RFB-2023-64  
SCHENECTADY COUNTY COURTHOUSE CONDENSATE DRAIN

ADDENDUM #3

Issued Date 1/13/23

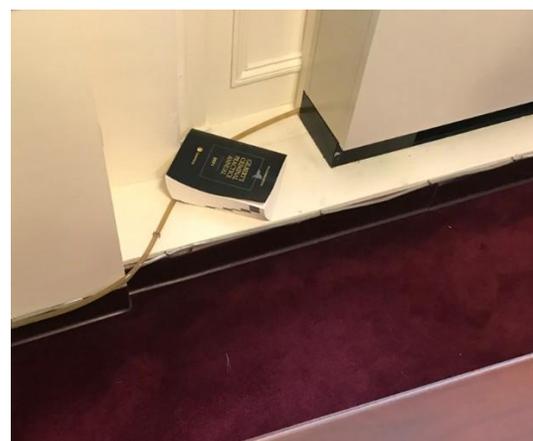
Question #13: Can pictures of Men's / Women's bathroom Room 119 on page P101 be provided. This was inaccessible during the walk through.

Response: We do not have a picture of the toilet room. The storm pipe you are tying into is in the wall you can not see.
